(All SoC PN variants: TDA4AP/VP/AH/VH)
(Power Rail & GPIO Mapping Overview)

TPS6594133A NVM | Revision History

J784S4 EVM Leo + 2x High-Current Pwr Stages(HCPS) PDN-3A

TPS6594133A PMIC + TPS389006004 SVS Cold Boot-up Timing for PDN-3x

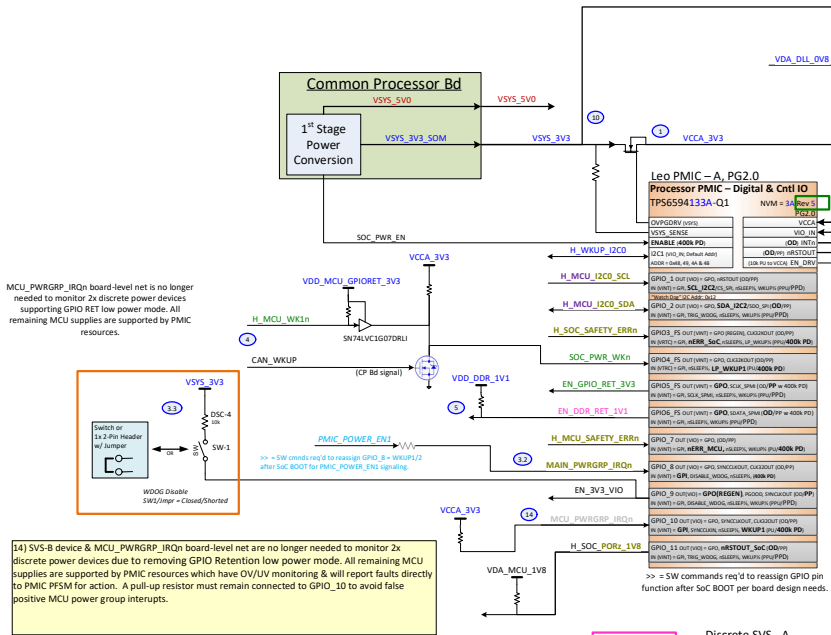
(2) The OR gate function enabling the discrete LDO supplying 1.8V to LPDDR4 VDD1 (internal bias voltage) needs to revert back to original discrete FET OR gate circuitry (see PROC141E2_SCH or snap-shot below). Reason for reverting is due to the OR gate needing a max input voltage threshold less than 1.05V (-5% of 1.1V) since the EN_DDR_RET_1 input signal is sourced from an open-drain PMIC. GPIO with PU resistor to VDD_DDR_1V1 supply with +/-5% supply tolerance. In addition, the OR gate needs to remain energized during DDR Retention low power mode when only VDD_DDR_1V1 & VDD1_DDR_1V8 rails remain energized. Therefore, the OR gate supply must use V515_3V3 or VCCA_3V3 input supply that remains on in OR Ret hold mode. The single logic gate IC (SN74LVC1G97-Q1) used for enabling other power resources interposed to 3.3V signaling levels can not be used with 1.1V signaling since its max input voltage threshold for 3.3V supply is ~2.2V.

(3) The Safety Voltage Supervision (SVS-4 & SVS-8) actively connections need to be changed from "Always On" VCCA_3V3 (+VVS_3V3) to "PMIC controlled" power rail so that resetting of an asserted IRQn signal by power cycling SVDS devices. During functional testing, it was discovered that an SVS's asserted IRQn could not be reset if PMIC processor I2C comm with SVS devices is lost. This will happen if a MCU Power Error occurs (i.e., fault on a MCU supply) since this will cause the PMIC PSM1 to transition the system to the desired Safe Recovery state (powers down all SOC supplies). However, if the SOC PSM's input voltage VCCA_3V3 remains energized, then the energized SVDS would maintain an asserted IRQn and the system will not be able to execute a cold boot attempt due a previously asserted IRQn. To prevent this situation, the SVS devices must be configured to allow the PMIC to control the power rails. When the SVS devices are configured to "Always On" VCCA_3V3 supply connections with a PMIC controlled power rail (VDD_MCU_0V3), the SVS devices will have a power cycle event upon entering the Safe Recovery state (per table below). If a fault occurs on a Main domain supply, the PMIC will transition the system to MCUS Only state which allows I2C comms to evaluate & potentially log the fault source. The MCU can use I2C comms to clear an asserted IRQn if a system cold boot attempt is desired.

The SVS devices will also respond to a fault rate since a fault might clear if it's due to a random noise event or temperature dependence. The SVS device's "Active" Input connection will need to be connected to VDD_MCU_0V3 supply connection as well as VCCA_3V3 supply connection is enabled as part of the SOC power up seq. This avoids driving a high logic signal into an unenergized device.

(Power Rail & GND Mapping Overview)

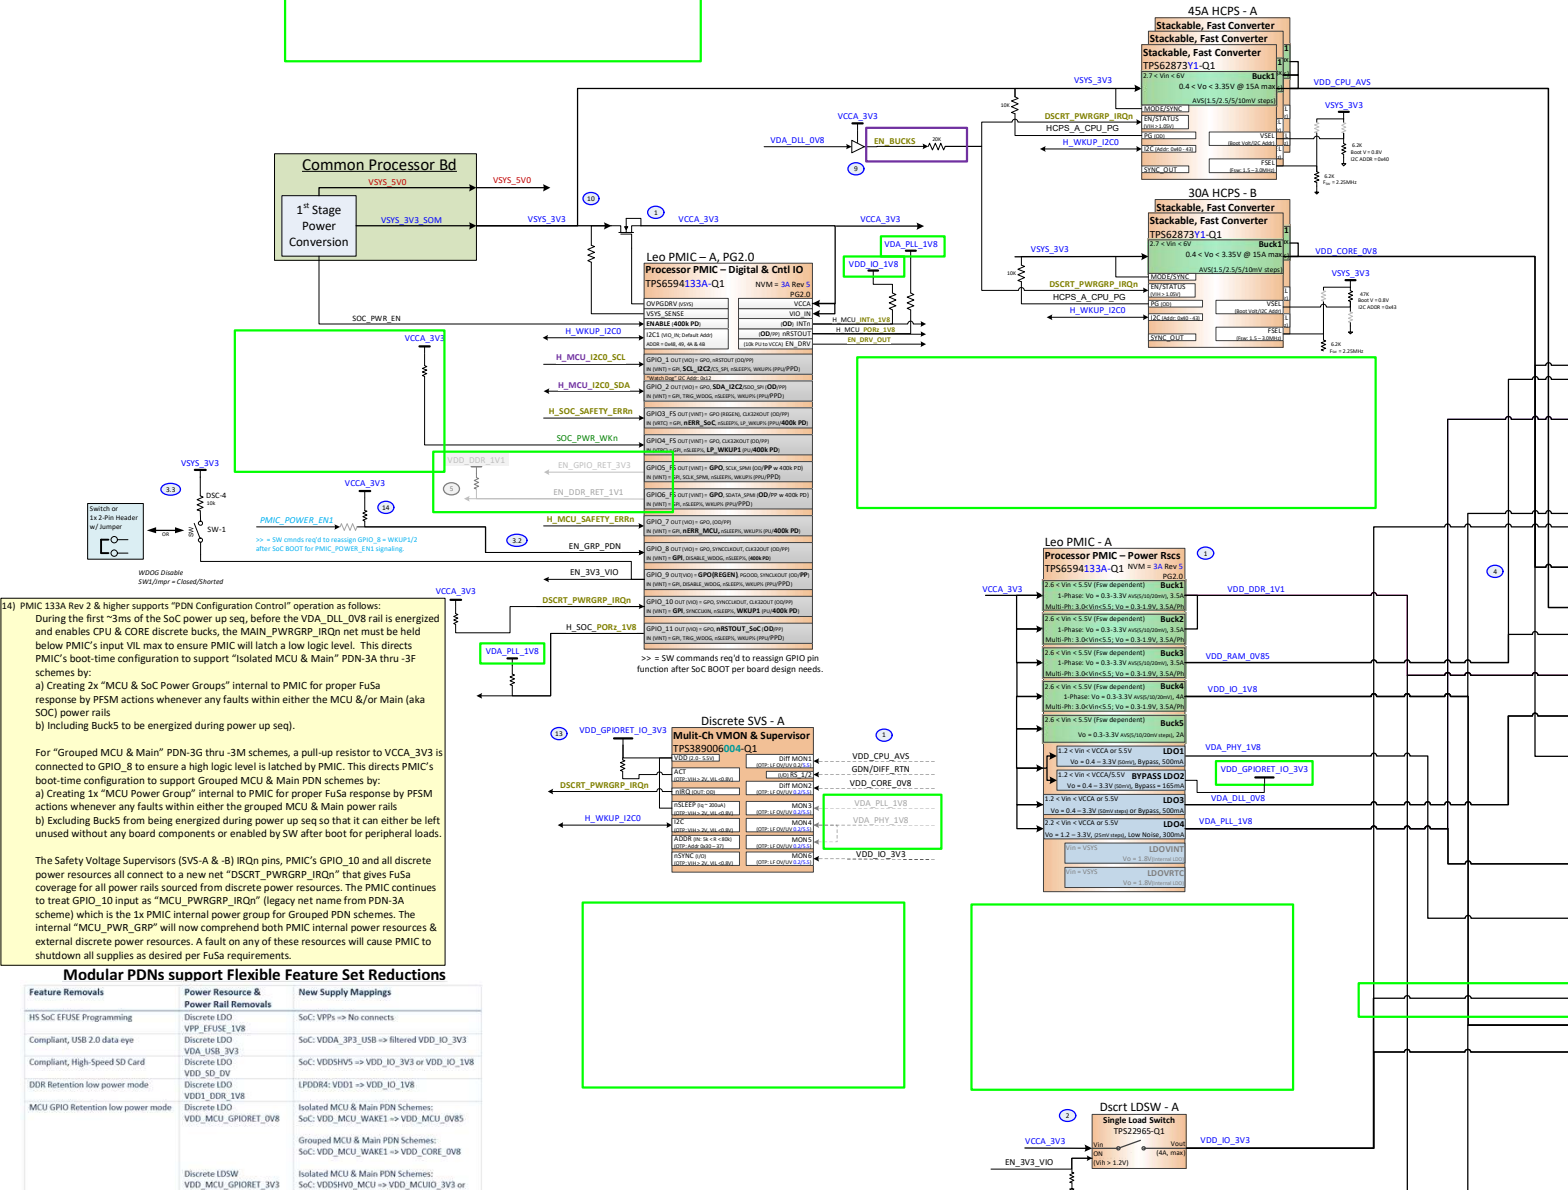
- Updated discrete buck's ENABLE input connections to more accurately show the 20k resistor located in-line to voltage translator output.
 - Updated Note 9, example #2 text & diag to show 20k resistor in-line with buck's ENABLE inputs.
-
- Fixed power rail connections to OSPI memories by correctly changing name from VDD_MCUIO_1V8 to VDD_IO_1V8 for Grouped PDN scheme.

J784S4 PDN-3A scheme)

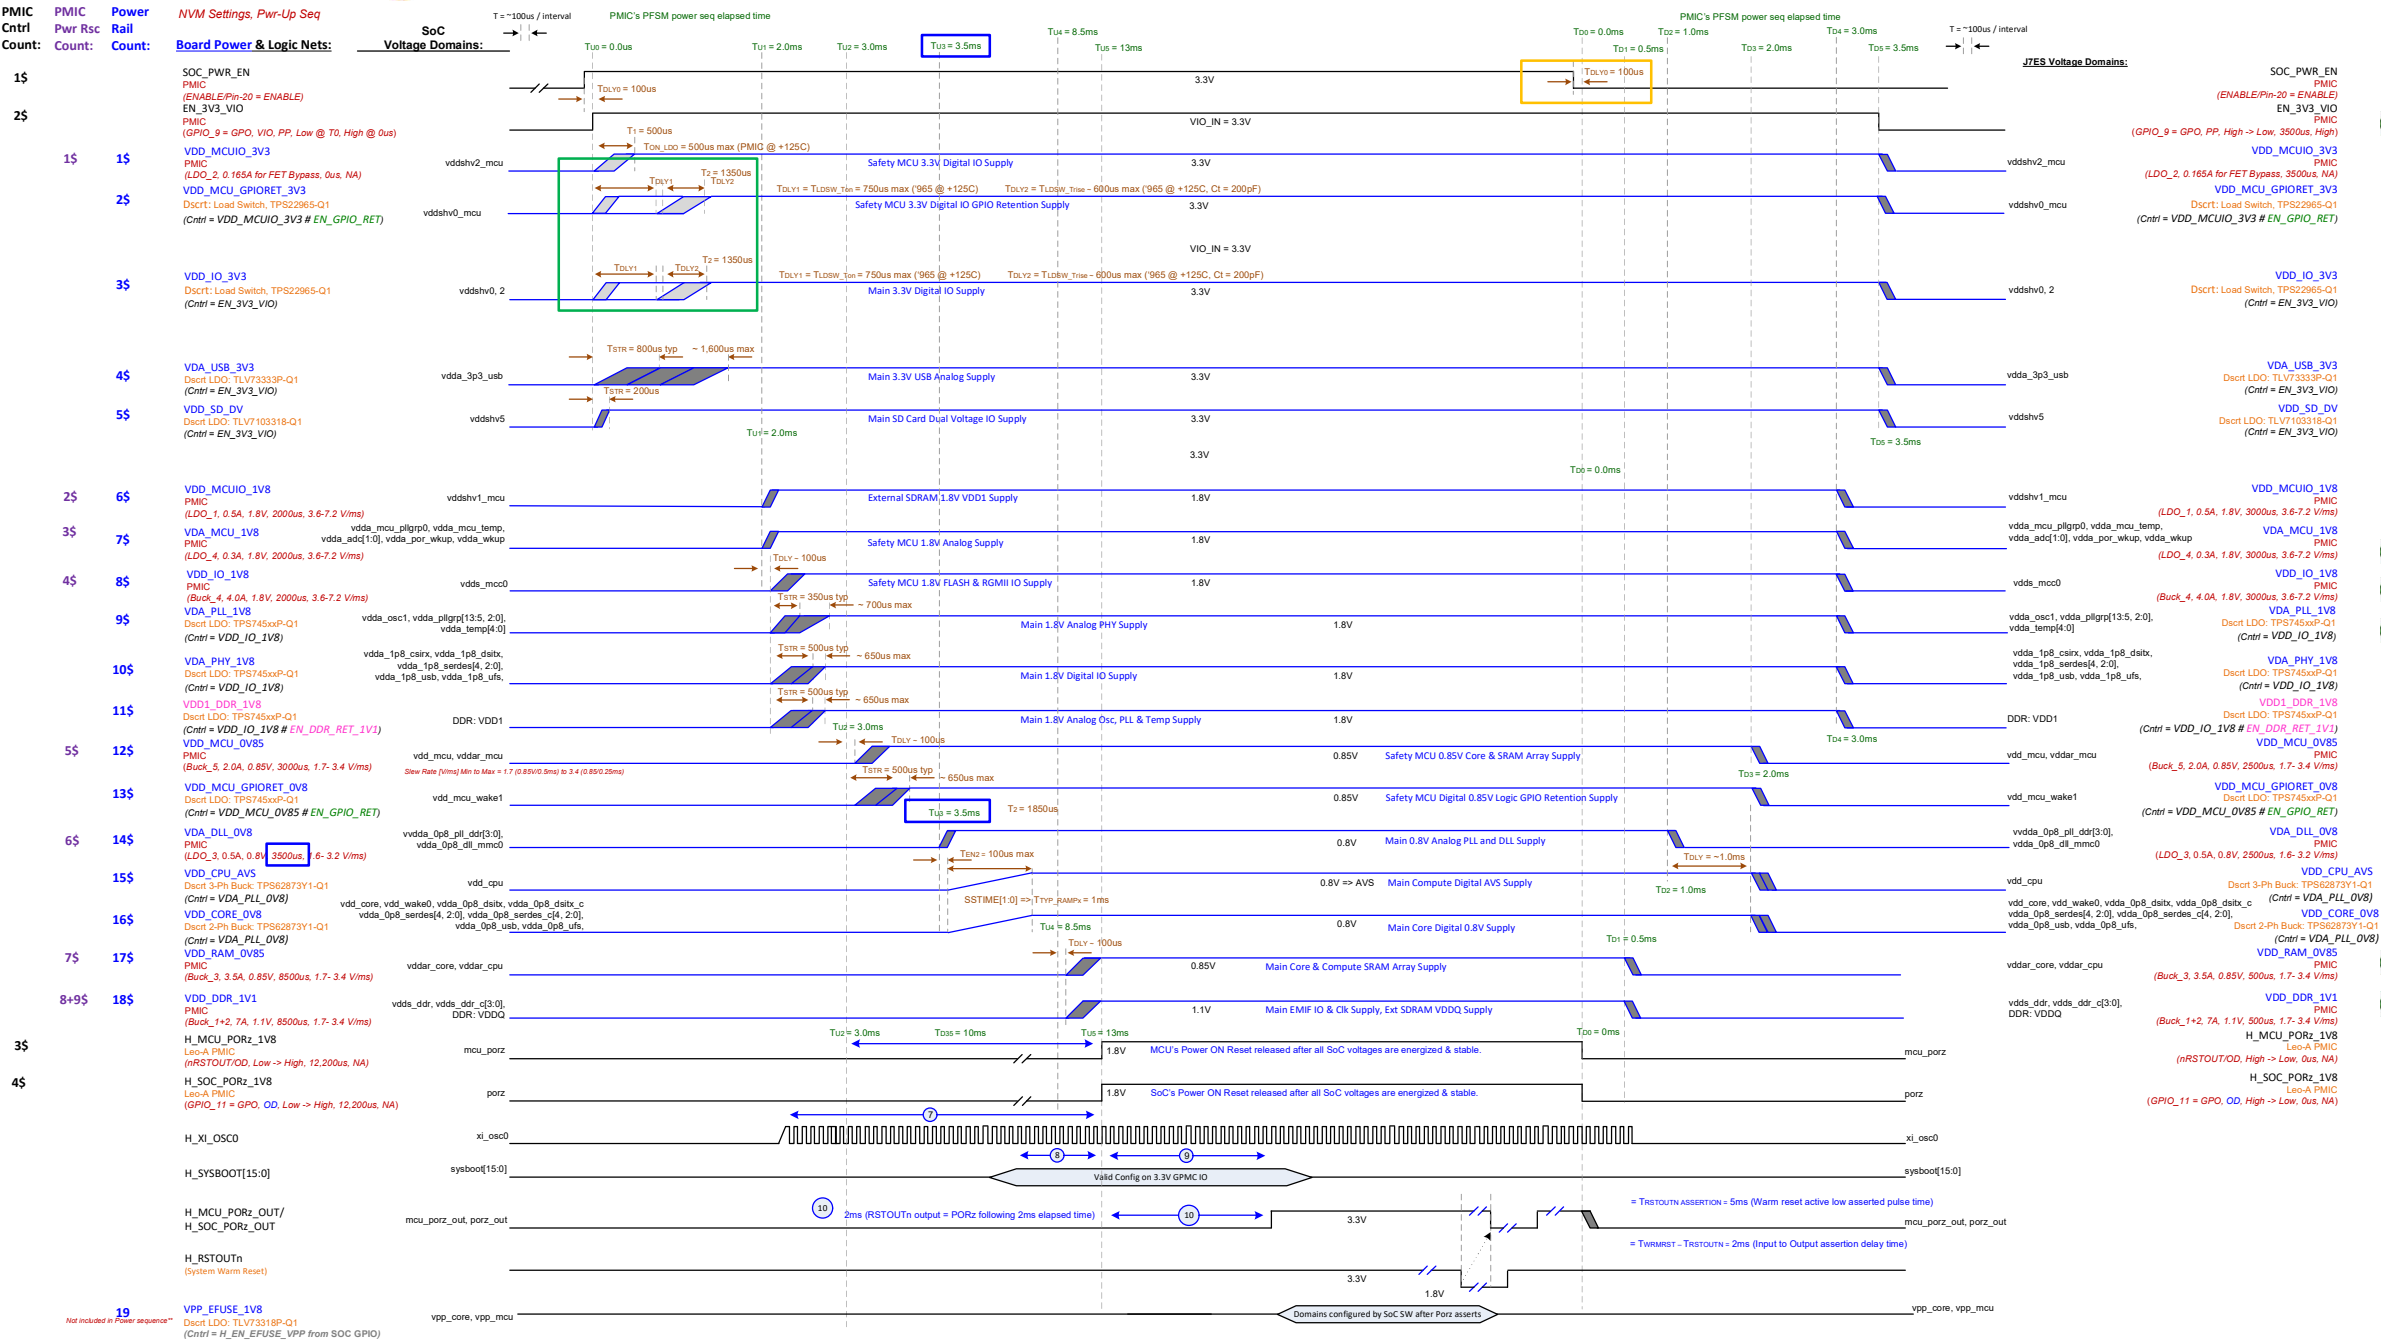
1. Corrected power up seq timing diagram to correctly show time btw pwr up seq Time Step #2 vs #3 as only 0.5ms (instead of 1.0ms).

1. Corrected diag to show SOC_PWR_EN (PMIC_ENABLE input) signal asserting low 0.1ms (PMIC's internal delay T_{OLV0}) before PMIC's state machine begins executing power down seq by 1st setting MCU_PORz & SOC_PORz low.

1. Corrected diag to show both VDD_GPIORET_IO_3V3 & VDD_IO_3V3 min enable time could be ~0.1ms after enabling signals (VDD_MCUIO_3V3 & EN_3V3_IO respectfully).

2. An "Immediate Shutdown/Power Down Seq" has recently been approved and will be add to an upcoming data manual version. This simplifies SOC power down to only require both PORz signals to be set low for 1-2us before disabling SoC input supplies in any order.

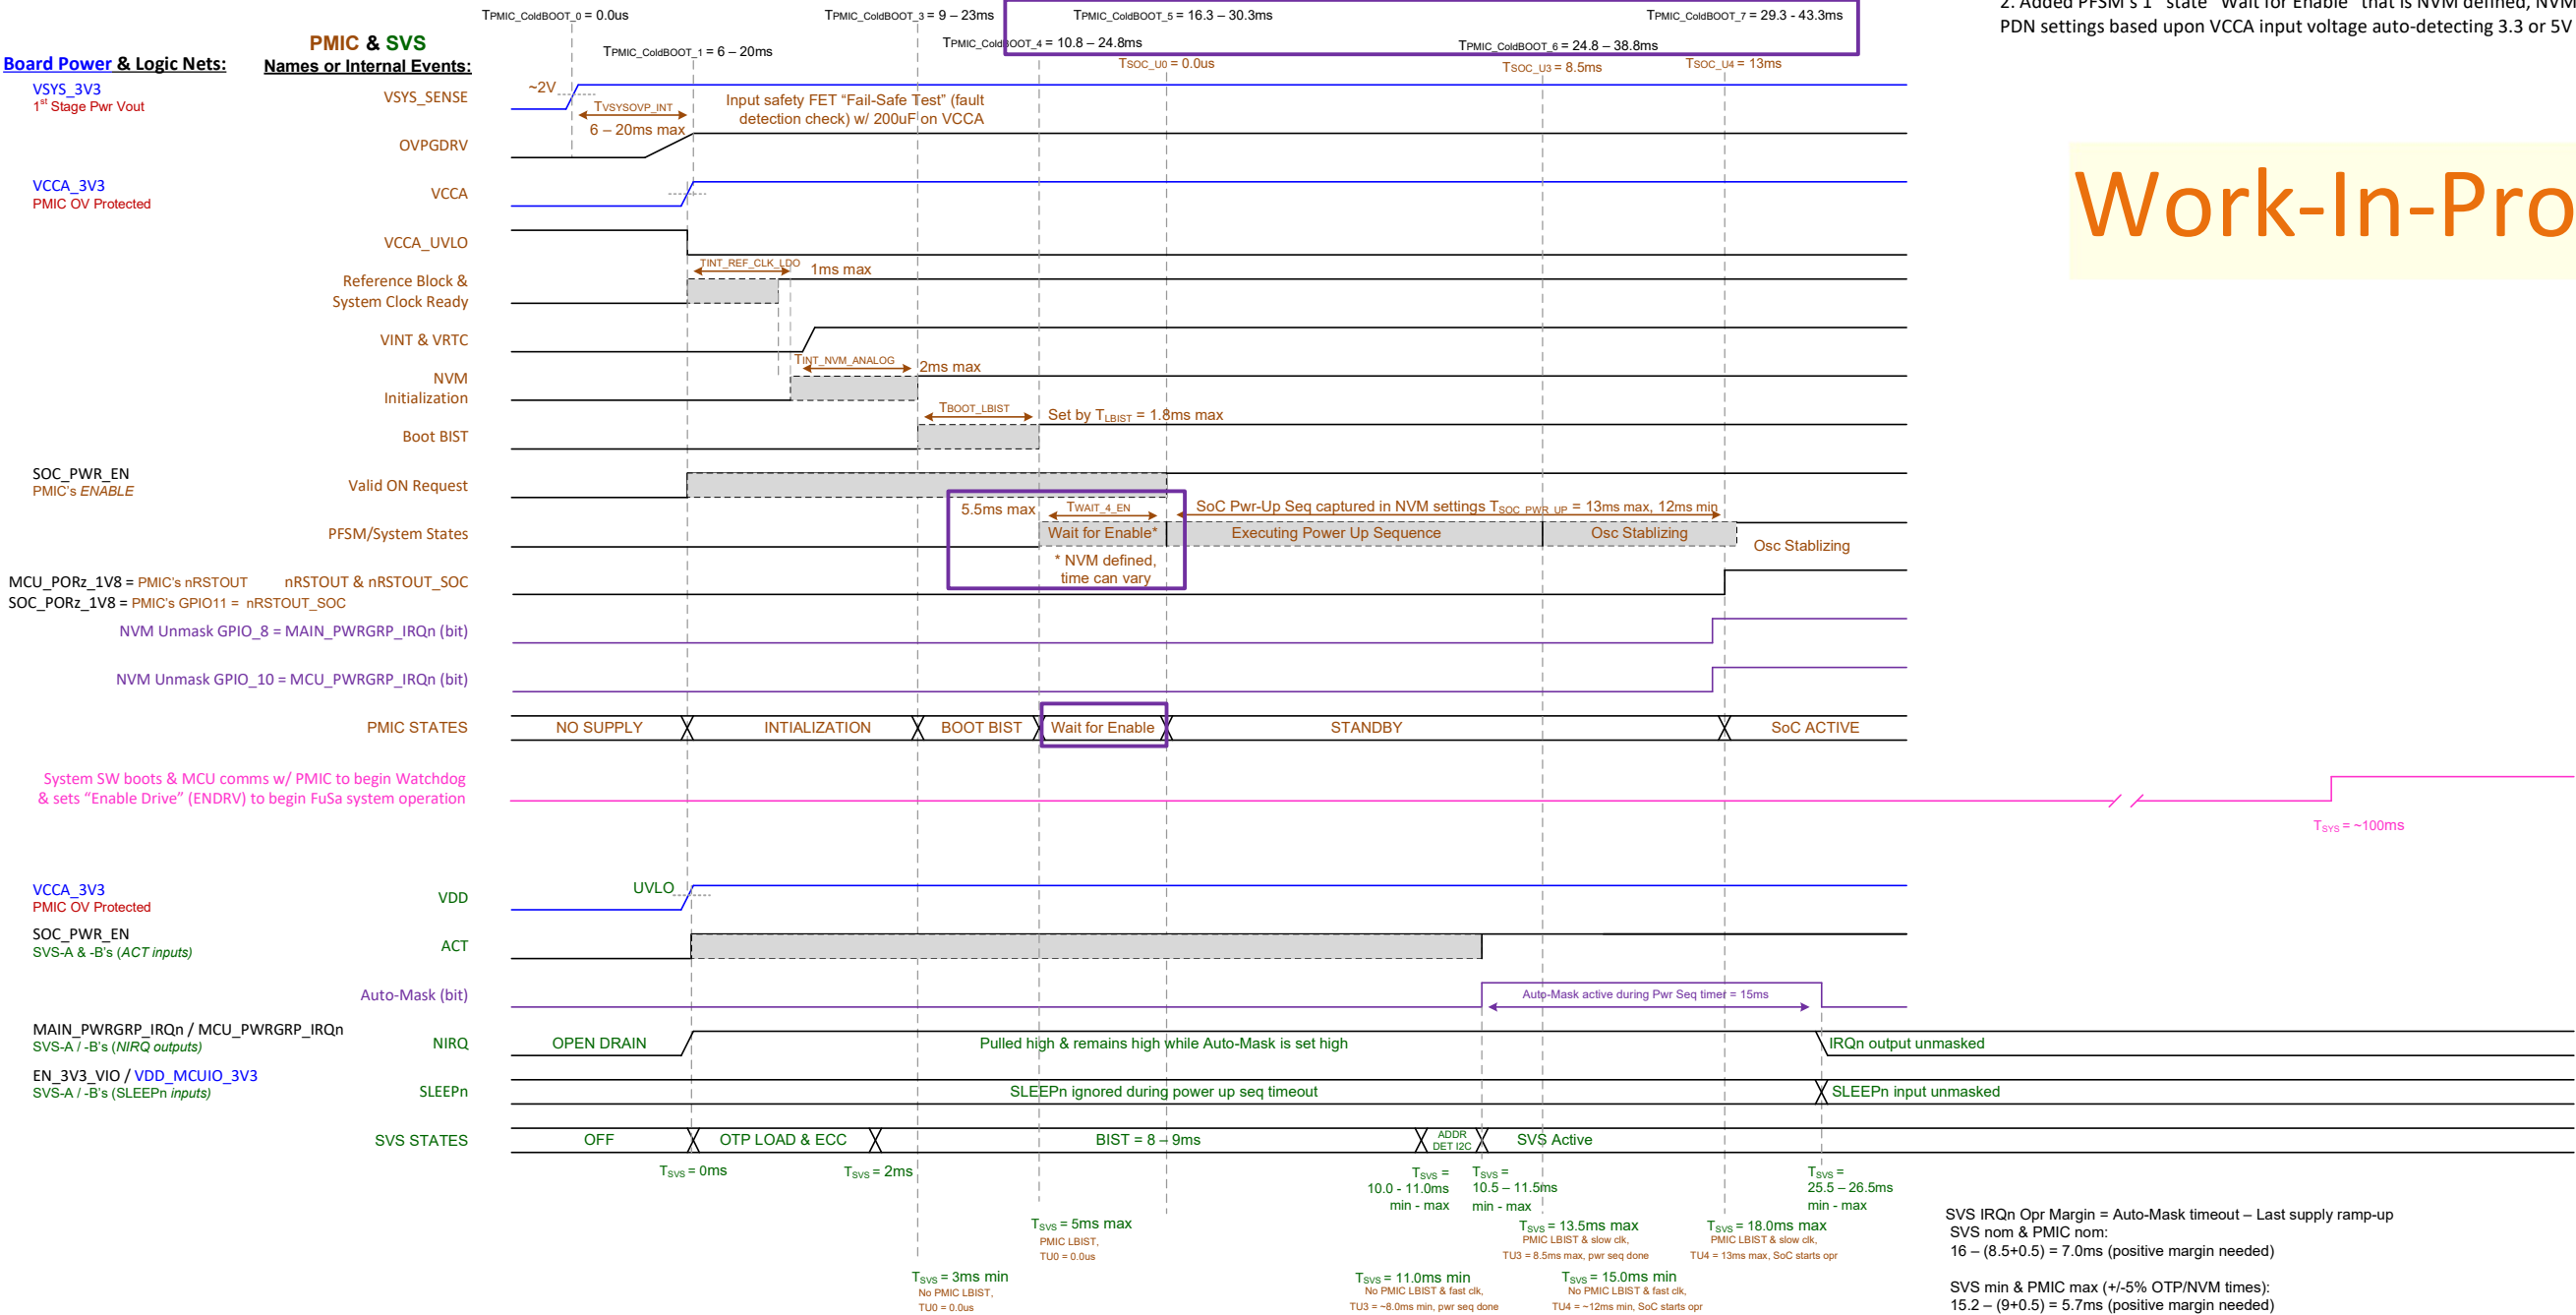
SVS IRQn Opr Margin = Auto-Mask timeout – Last supply ramp-up
SVS nom & PMIC nom:
16 – (8.5+0.5) = 7.0ms (positive margin needed)
SVS min & PMIC max (+/-5% OTP/NVM times):
15.2 – (9+0.5) = 5.7ms (positive margin needed)
